Australian Turf Club and Sydney's Light Rail project: Urban Impact Summary document- 18.12.2013

Sydney's Lightrail: Impacts Summary Sheet

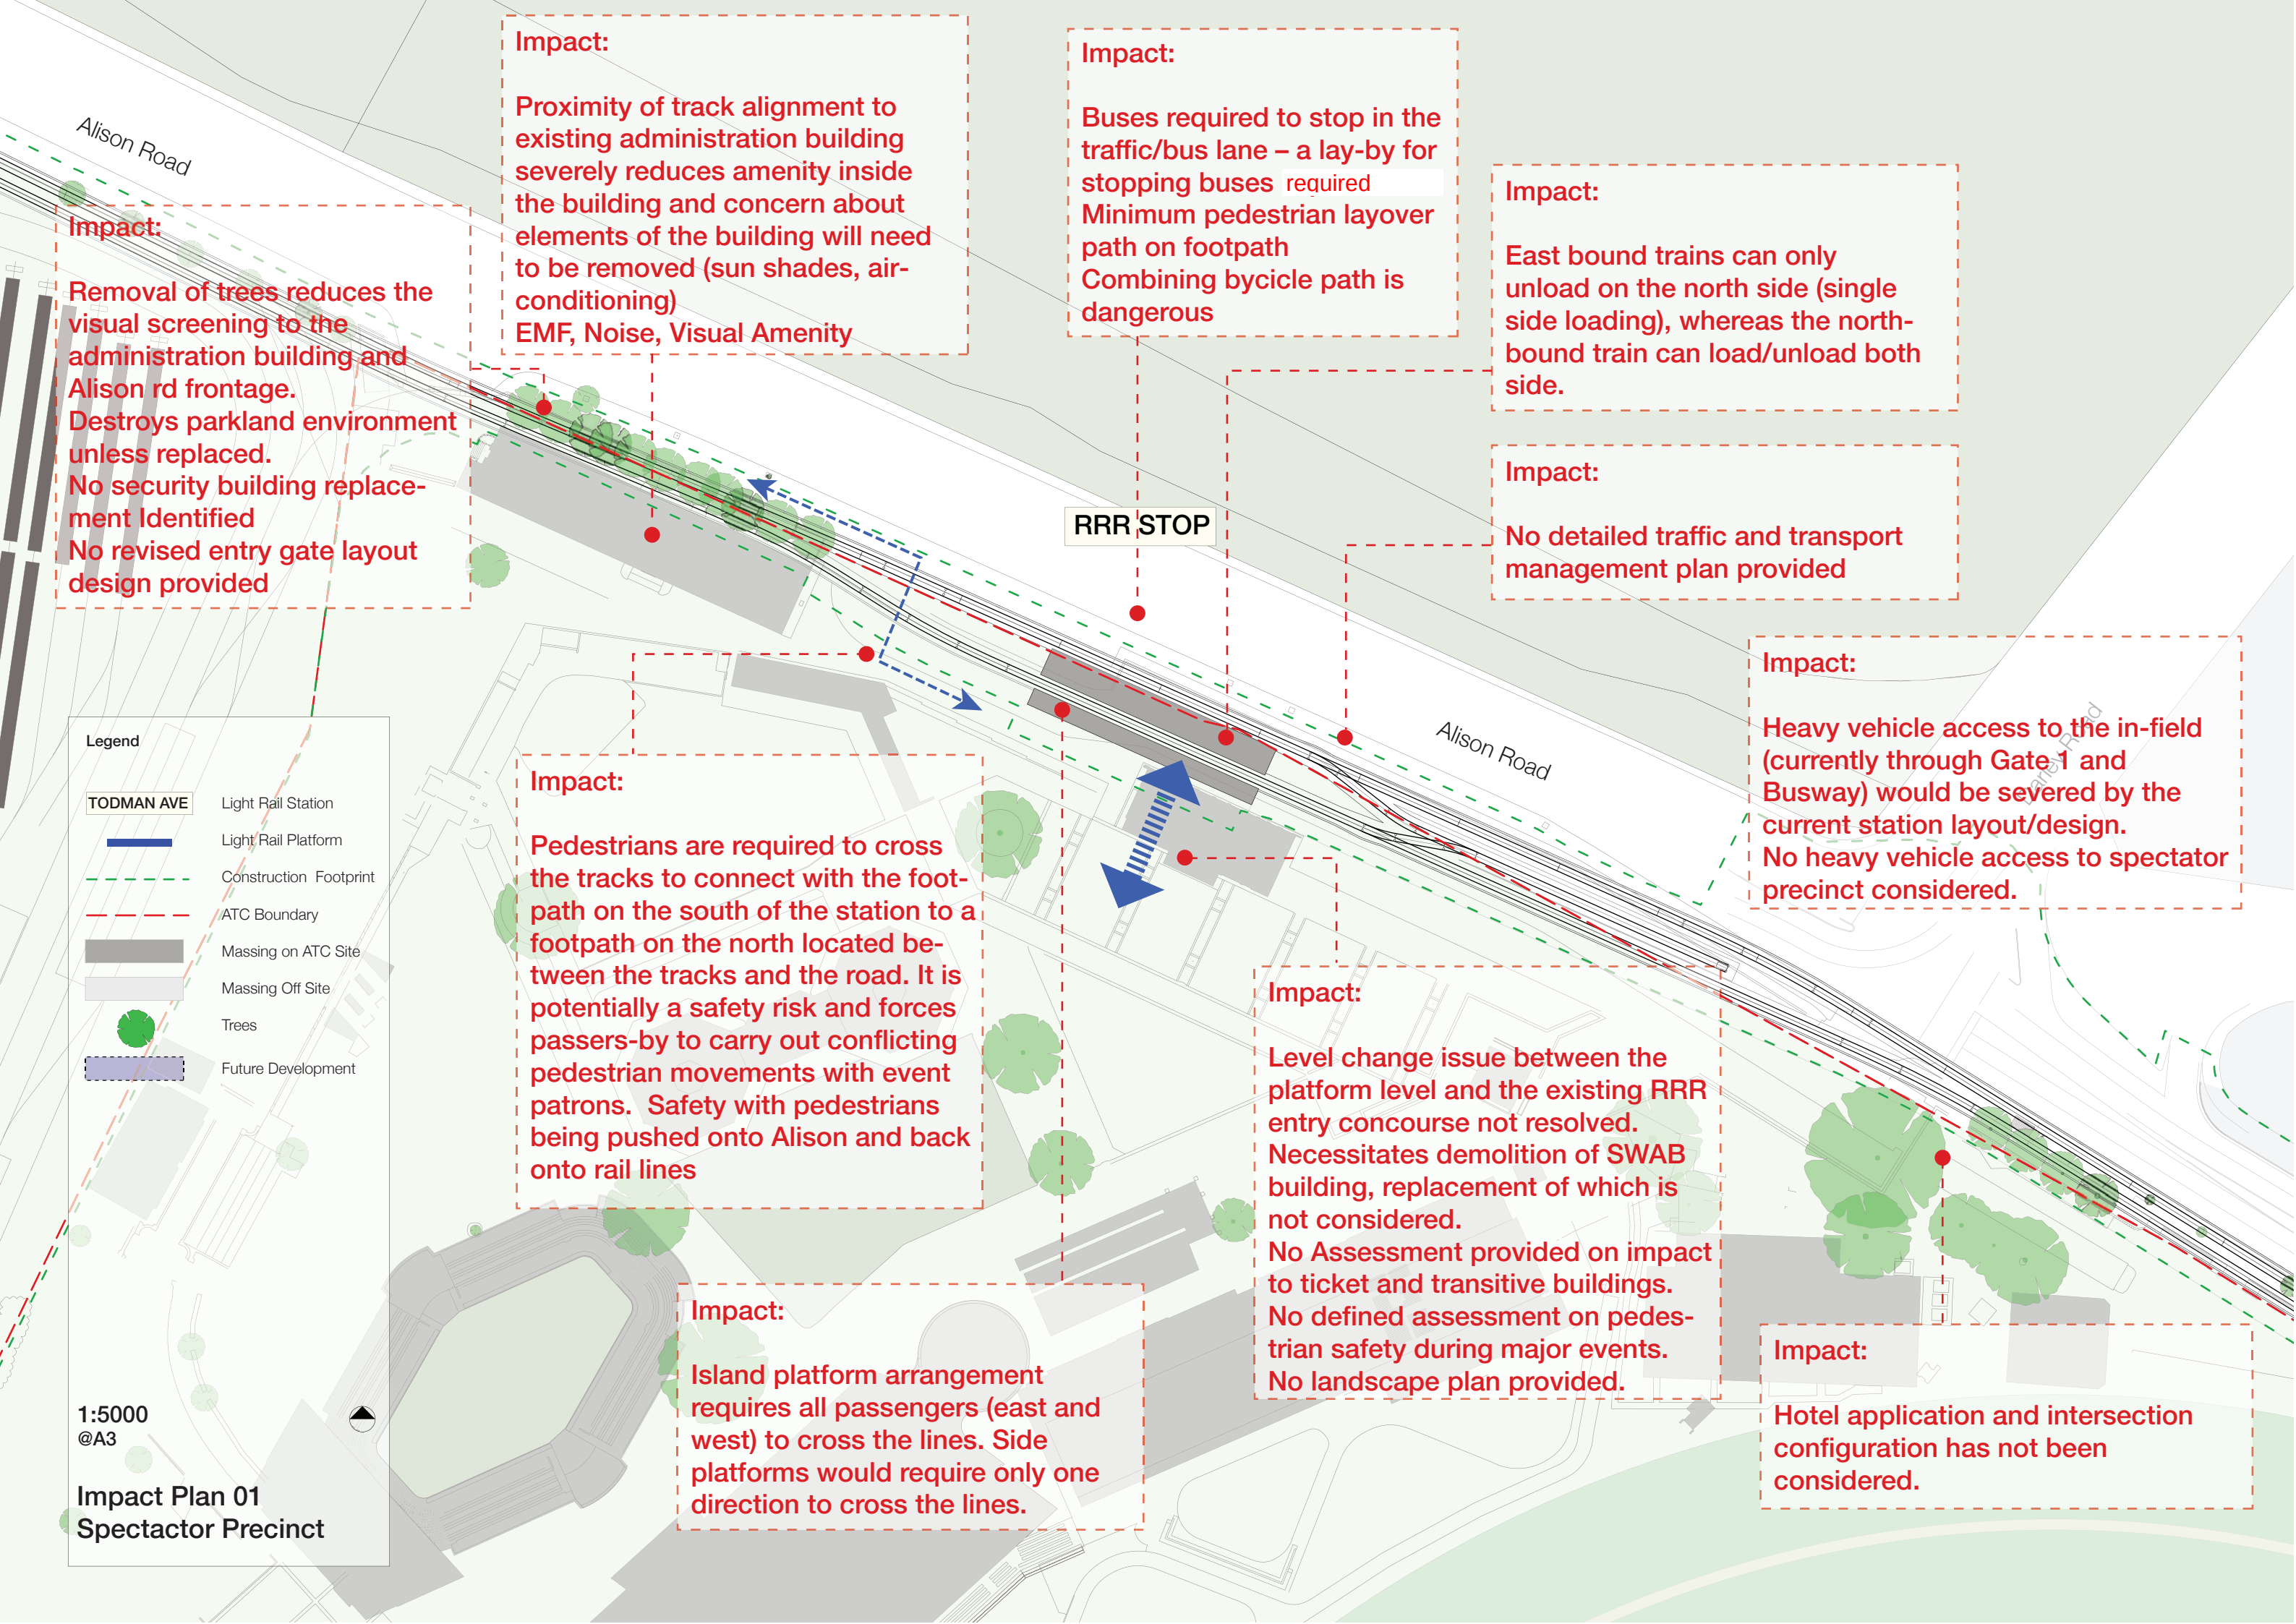
Proximity of track alignment to existing administration building severely reduces amenity inside the building and concern about elements of the building will need to be removed (sun shades, air-conditioning)
EMF, Noise, Visual Amenity

Buses required to stop in the traffic/bus lane – a lay-by for stopping buses required
Minimum pedestrian layover path on footpath
Combining bicycle path is dangerous

East bound trains can only unload on the north side (single side loading), whereas the north-bound train can load/unload both side.

No detailed traffic and transport management plan provided

Heavy vehicle access to the in-field (currently through Gate 1 and Busway) would be severed by the current station layout/design.
No heavy vehicle access to spectator precinct considered.

Level change issue between the platform level and the existing RRR entry concourse not resolved.
Necessitates demolition of SWAB building, replacement of which is not considered.
No Assessment provided on impact to ticket and transitive buildings.
No defined assessment on pedestrian safety during major events.
No landscape plan provided.

Hotel application and intersection configuration has not been considered.

Pedestrians are required to cross the tracks to connect with the footpath on the south of the station to a footpath on the north located between the tracks and the road. It is potentially a safety risk and forces passers-by to carry out conflicting pedestrian movements with event patrons. Safety with pedestrians being pushed onto Alison and back onto rail lines

Island platform arrangement requires all passengers (east and west) to cross the lines. Side platforms would require only one direction to cross the lines.

Removal of trees reduces the visual screening to the administration building and Alison rd frontage.
Destroys parkland environment unless replaced.
No security building replacement Identified
No revised entry gate layout design provided

Impact:
Existing access point on Alison Road is removed.
All access points to be maintained unless agreed.

Impact:
Possible Building Demolition.

Impact:
No recognition of the approved stable facilities on the stop location.

Impact:
The retaining wall design will have a significant visual impact within the RRR precinct.

Impact:
Access to the RRR must be controlled at this location.

Impact:
Loss of trees will impact visual amenity and acoustic control from RRR.

Impact:
Loss of Fencing and gate replacement.
Detailed design provided to ensure safety, security and aesthetics.

Impact:
Existing access point on Wansey road (south of stop) is potentially compromised and limits access to the approved stable facilities.
Heavy vehicle access must be maintained .
Proposed equine stabling intersection should be controlled.

Impact Plan 02
Wansey Rd Stop

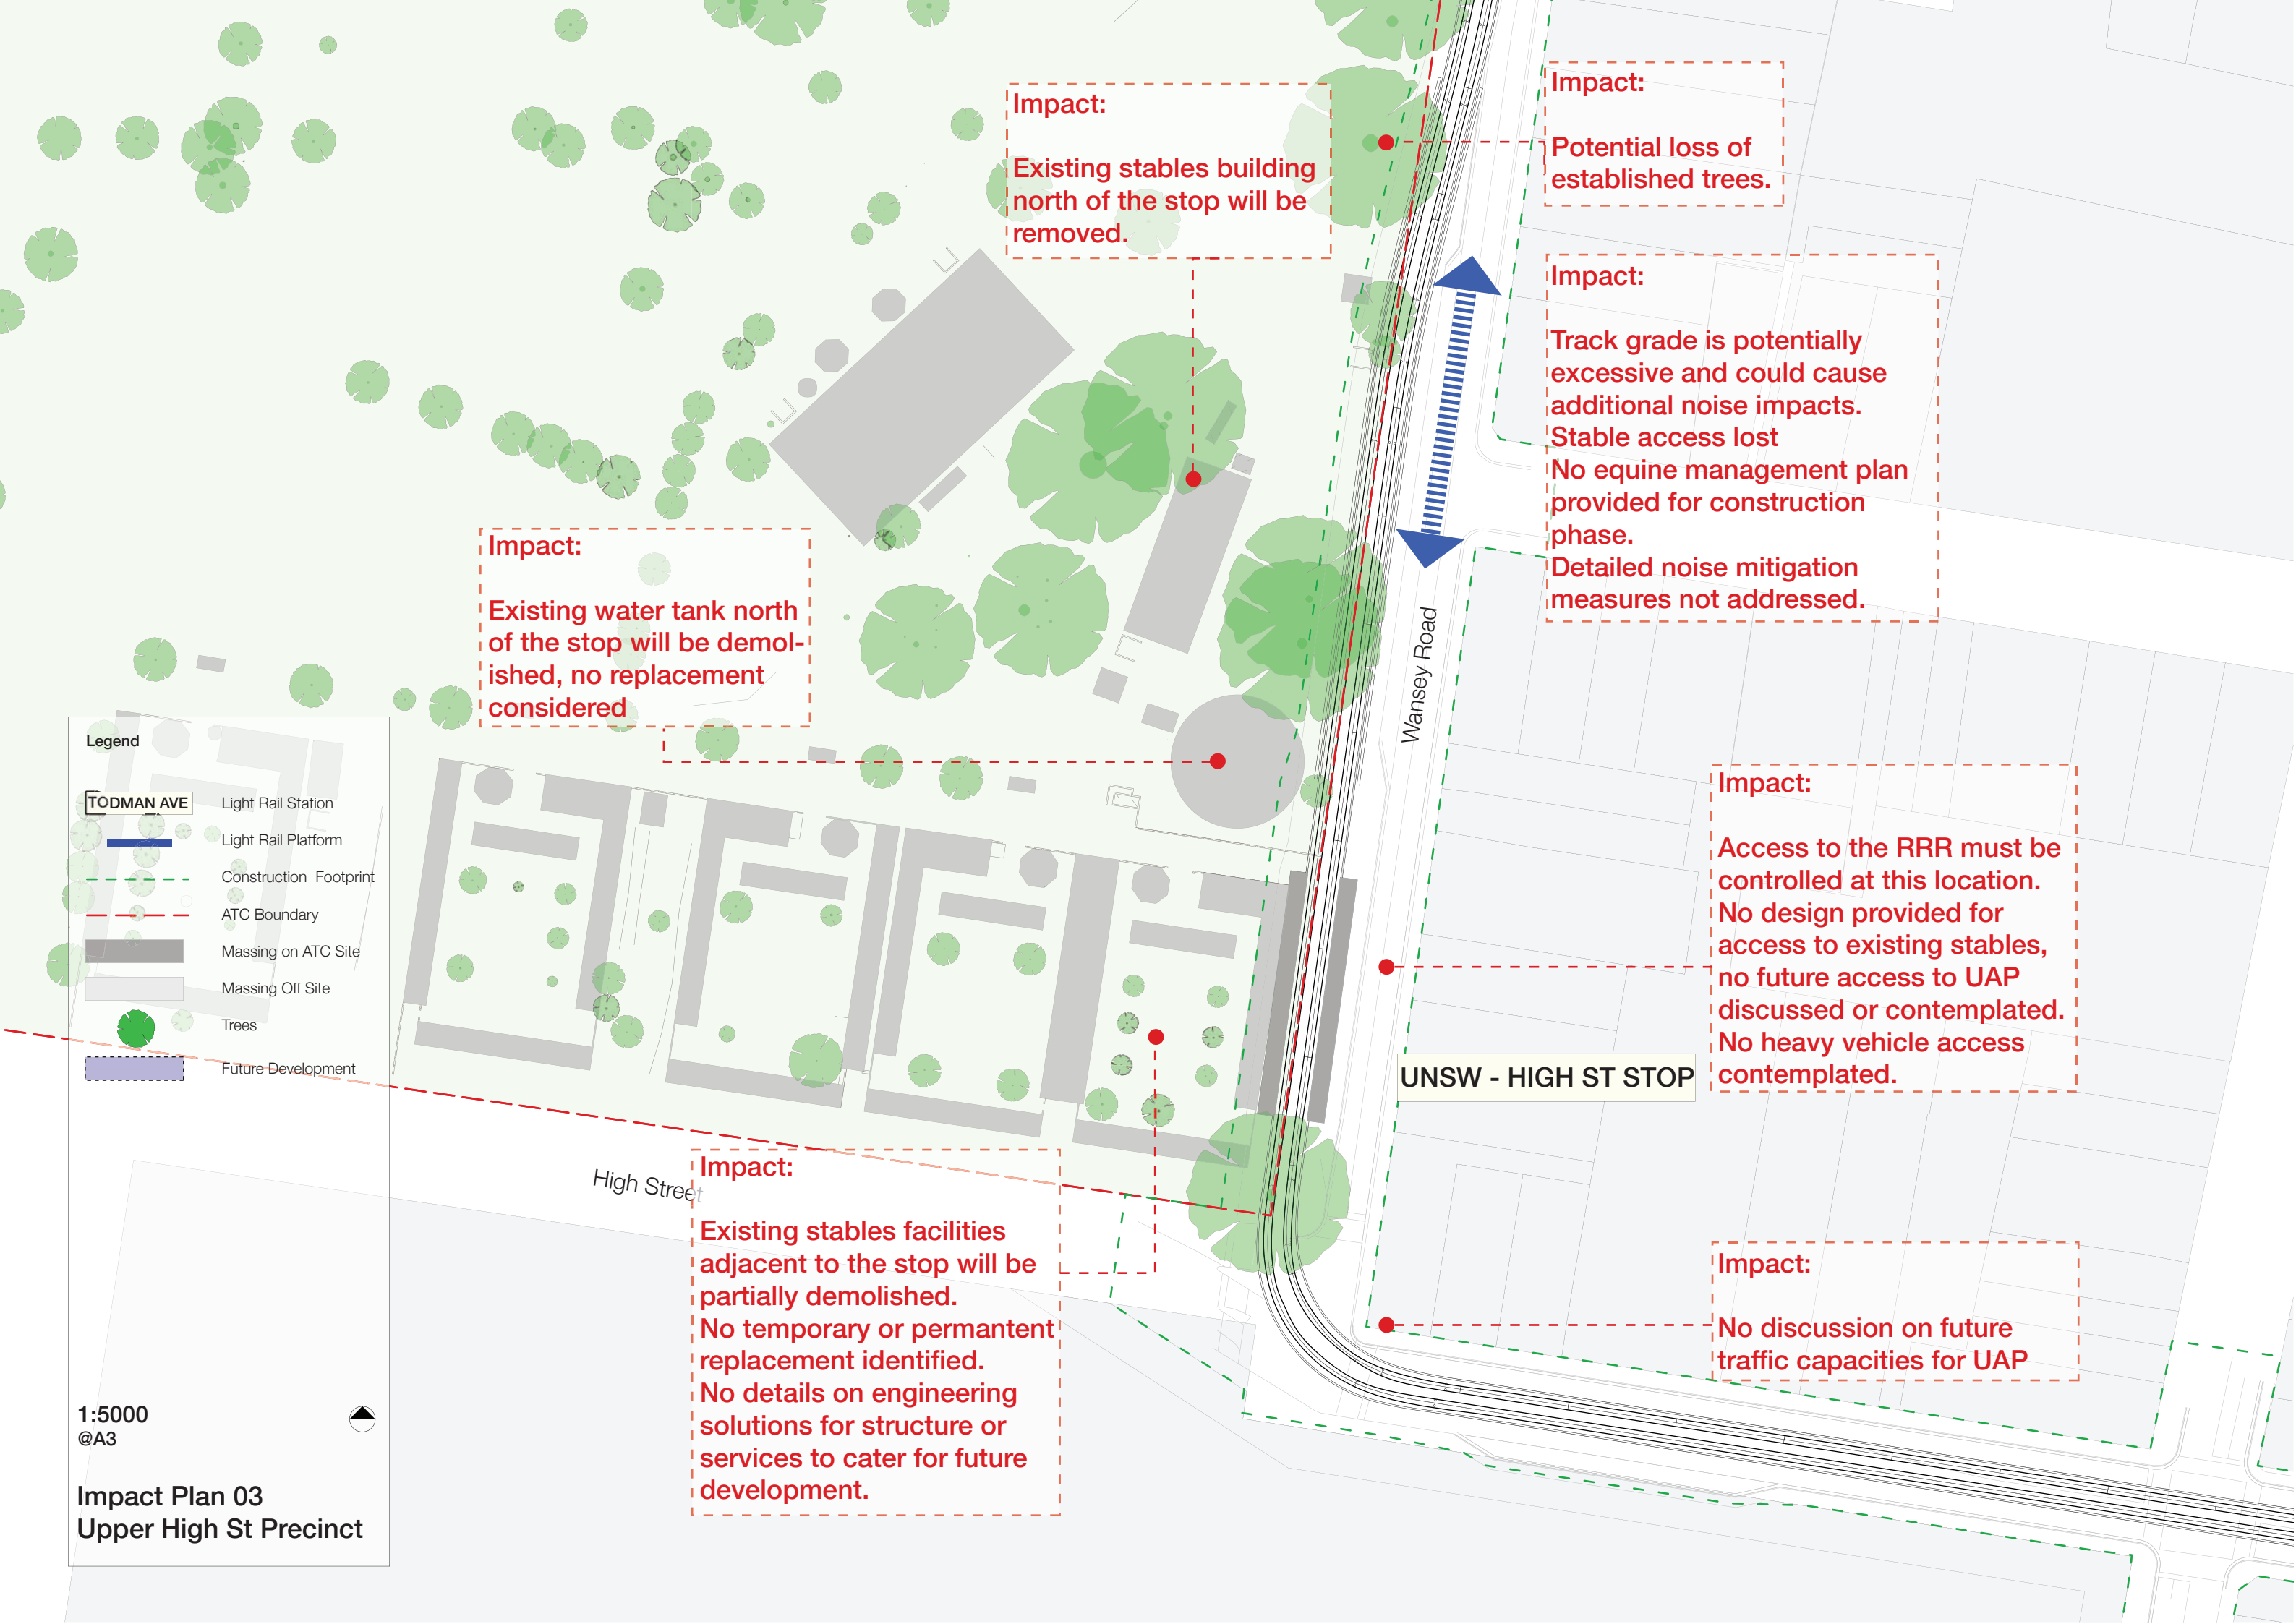
Existing stables building north of the stop will be removed.

Potential loss of established trees.

Track grade is potentially excessive and could cause additional noise impacts.
Stable access lost
No equine management plan provided for construction phase.
Detailed noise mitigation measures not addressed.

Existing water tank north of the stop will be demolished, no replacement considered

Access to the RRR must be controlled at this location.
No design provided for access to existing stables, no future access to UAP discussed or contemplated.
No heavy vehicle access contemplated.

No discussion on future traffic capacities for UAP

Existing stables facilities adjacent to the stop will be partially demolished.
No temporary or permanent replacement identified.
No details on engineering solutions for structure or services to cater for future development.
